Tennessee Valley Authority, 1101 Market Street, Chattanooga, TN 37402

CNL-17-074

Clinch River Nuclear Site
NRC Docket No. 52-047

Subject: Submittal of Supplemental Information Related to the Hydrologic Engineering in Support of the Clinch River Nuclear Site Early Site Permit Application - Groundwater

Figure 2.4.12C-27. Groundwater Heads—~~Fill~~Granular Backfill Hydraulic Conductivity of 10^{-2} cm/s in Profile A Model: a) Deep Foundation Embedment and b) Shallow Foundation Embedment

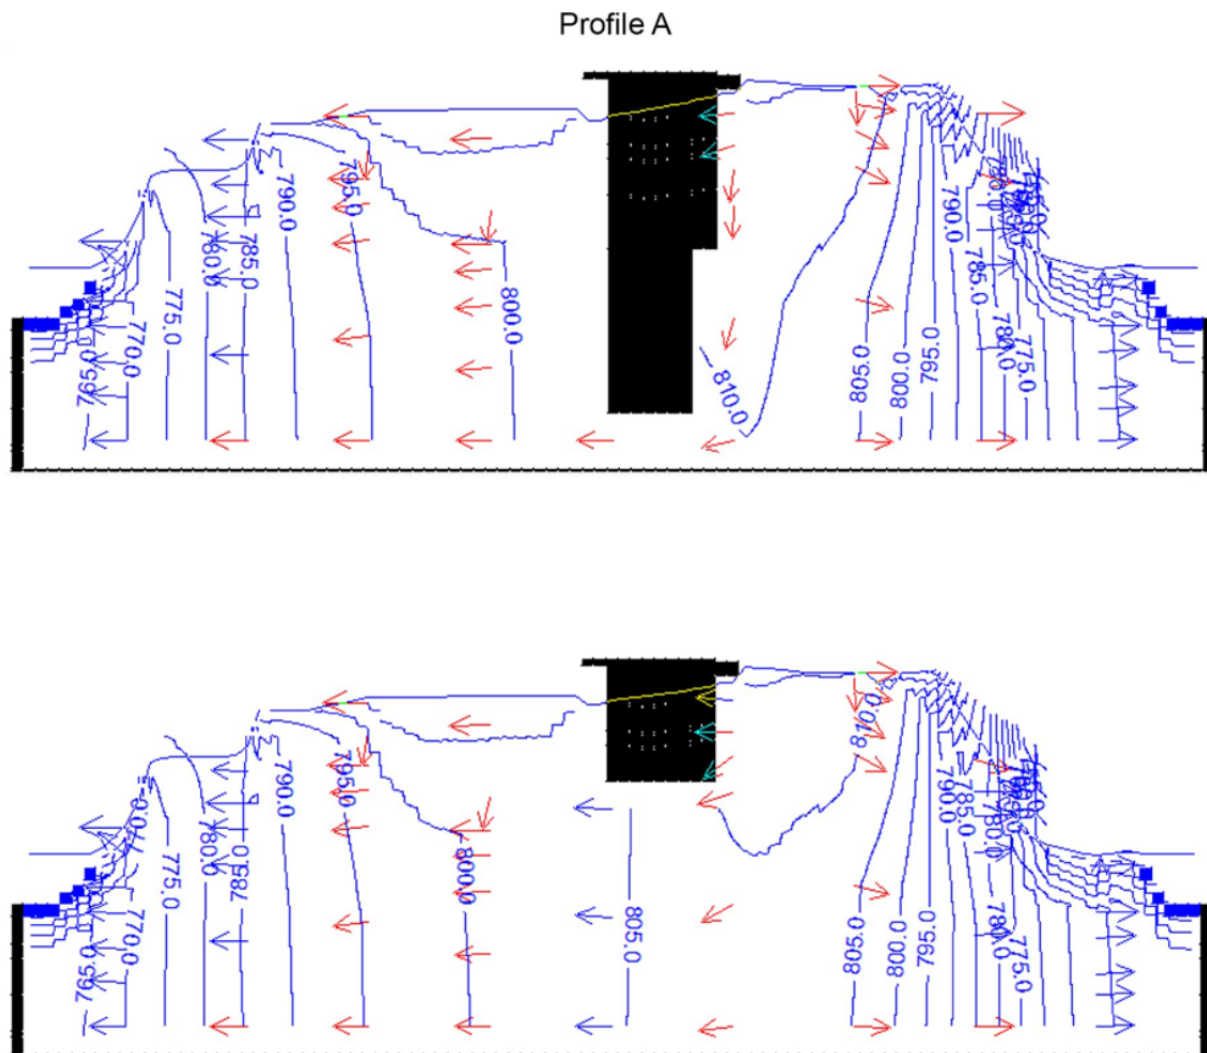
The terminology used to refer to the fill was not consistent throughout the SSAR. SSAR markups are provided below to consistently refer to the fill throughout the SSAR. Note that the SSAR markup for 2.4.12C.7.1, also includes the correction of a typographical error in the elevation of the SMR with shallowest foundation.

SSAR Figure 2.4.12C-27 is being revised as indicated (no revisions to the image have been made). Strikethroughs indicate text to be deleted. Underlines indicate text to be added.

Figure 2.4.12C-28. Groundwater Heads—~~Fill~~Granular Backfill Hydraulic Conductivity of 10^{-3} cm/s in Profile A Model: a) Deep Foundation Embedment and b) Shallow Foundation Embedment

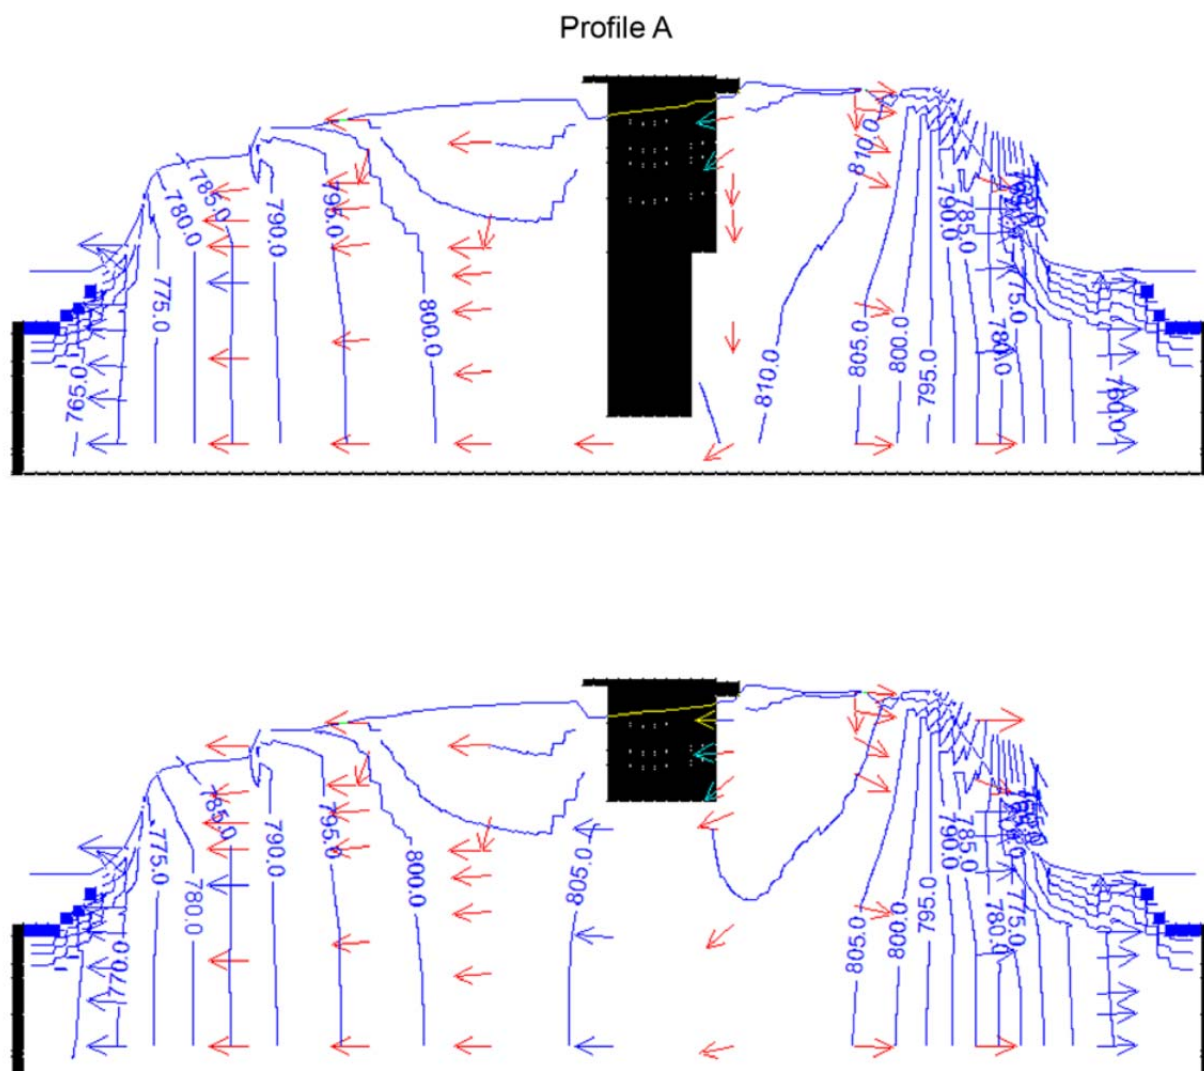
SSAR Figure 2.4.12C-28 is being revised as indicated (no revisions to the image have been made). Strikethroughs indicate text to be deleted. Underlines indicate text to be added.

Figure 2.4.12C-29. Groundwater Heads—~~Fill~~Granular Backfill Hydraulic Conductivity of 10^{-1} cm/s in Profile A Model: a) Deep Foundation Embedment and b) Shallow Foundation Embedment

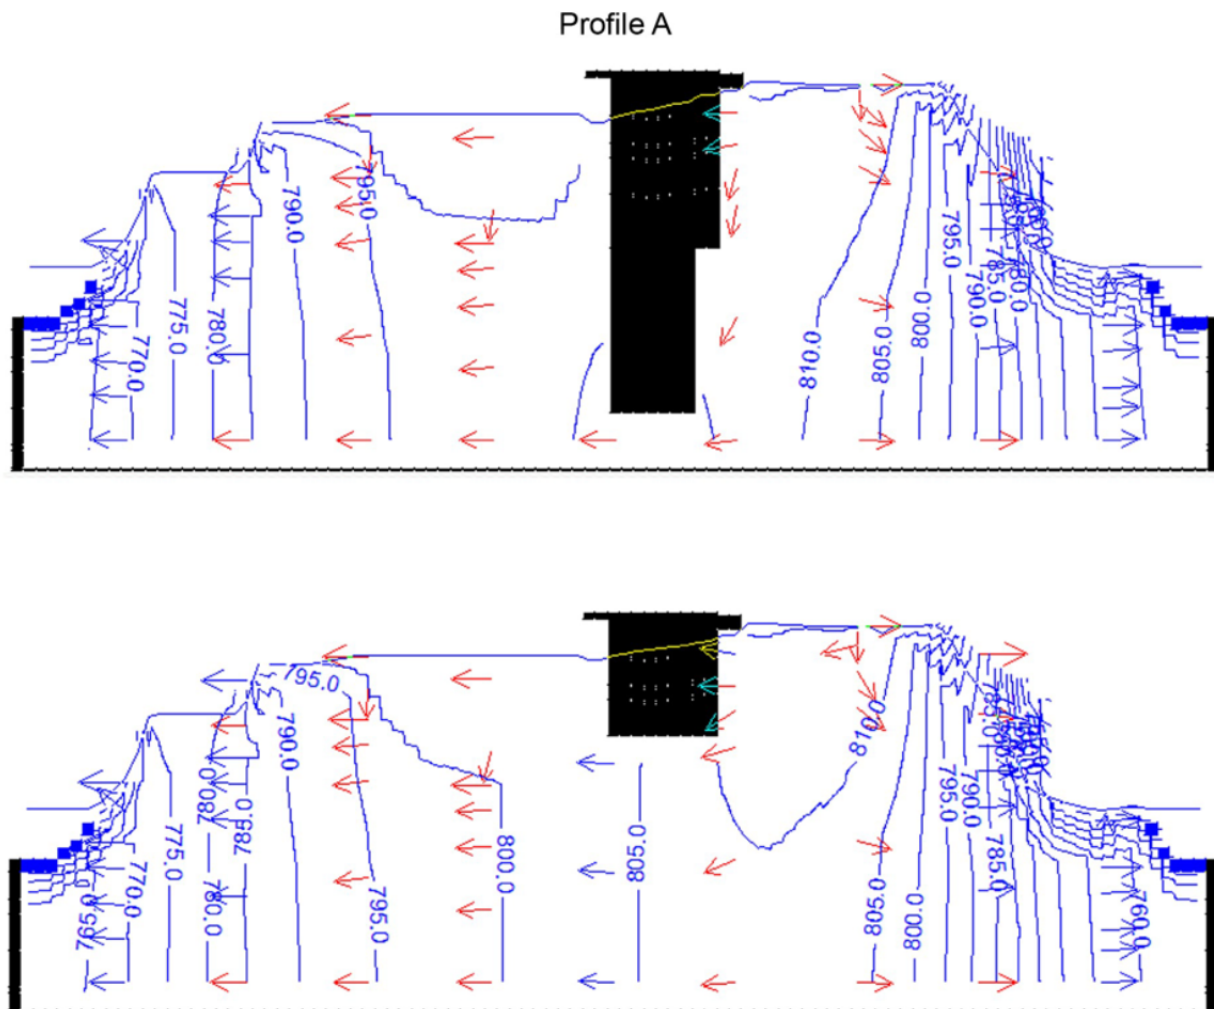
SSAR Figure 2.4.12C-29 is being revised as indicated (no revisions to the image have been made). Strikethroughs indicate text to be deleted. Underlines indicate text to be added.

Figure 2.4.12C-30. Groundwater Heads—~~Fill~~Granular Backfill Hydraulic Conductivity of 10^{-2} cm/s in Profile C Model: a) Deep Foundation Embedment and b) Shallow Foundation Embedment

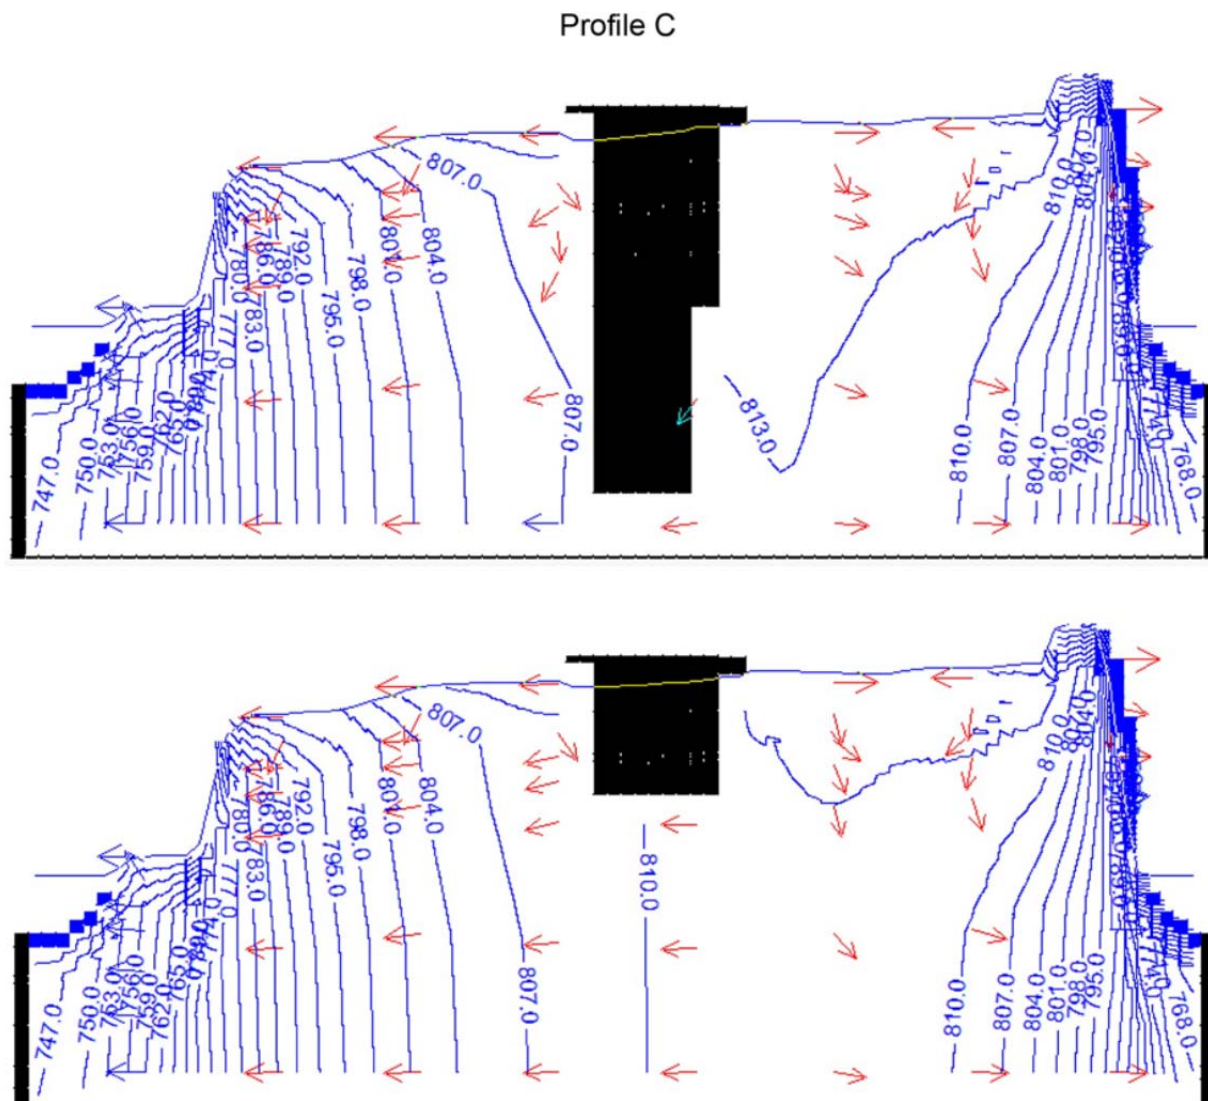
SSAR Figure 2.4.12C-30 is being revised as indicated (no revisions to the image have been made). Strikethroughs indicate text to be deleted. Underlines indicate text to be added.

Figure 2.4.12C-31. Groundwater Heads—Fill Granular Backfill Hydraulic Conductivity of 10^{-3} cm/s in Profile C Model: a) Deep Foundation Embedment and b) Shallow Foundation Embedment

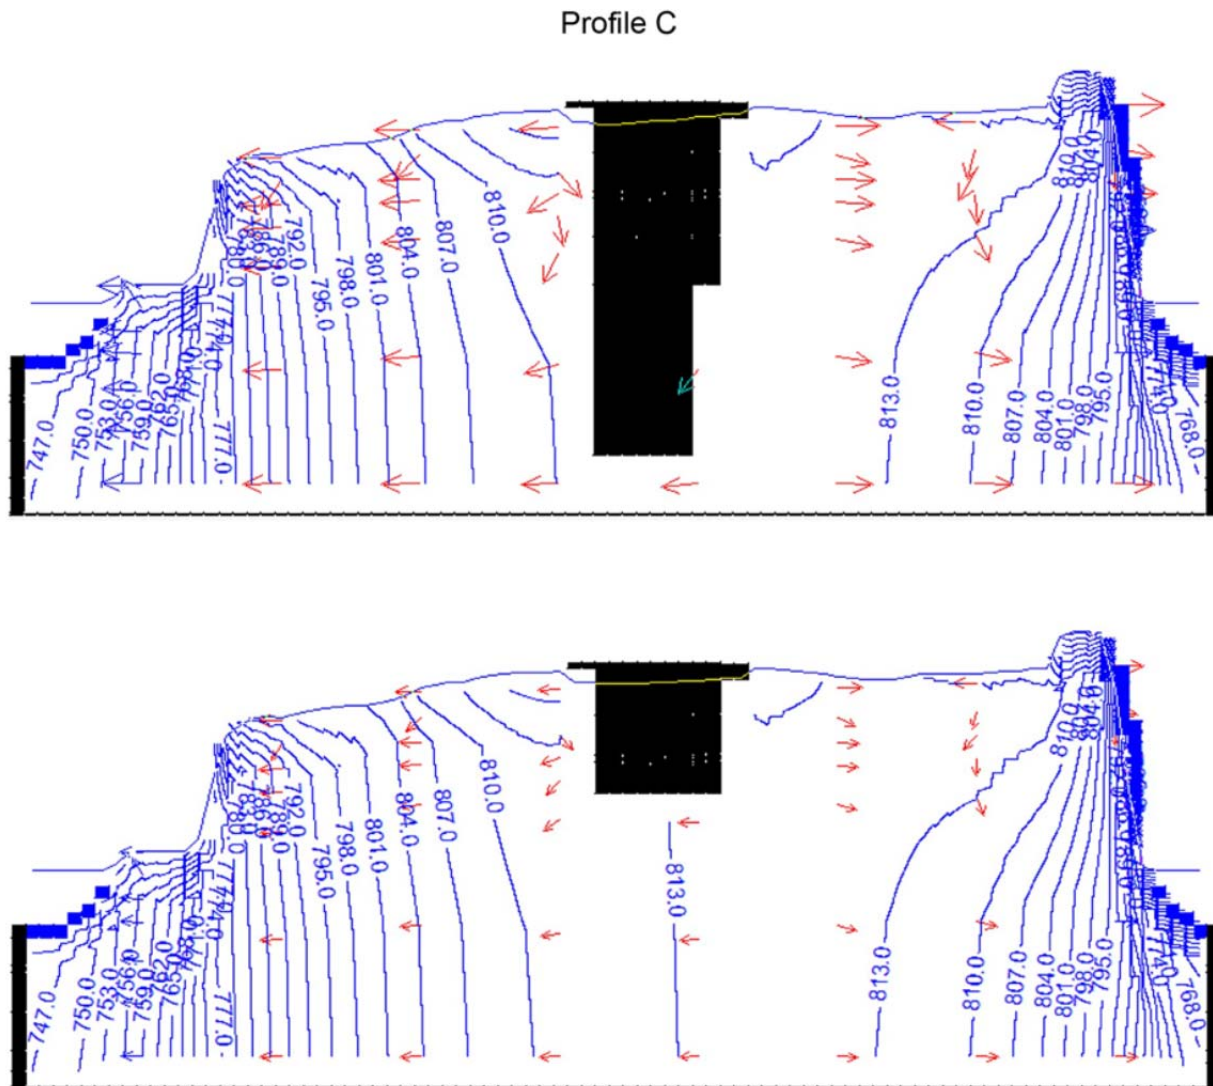
SSAR Figure 2.4.12C-31 is being revised as indicated (no revisions to the image have been made). Strikethroughs indicate text to be deleted. Underlines indicate text to be added.
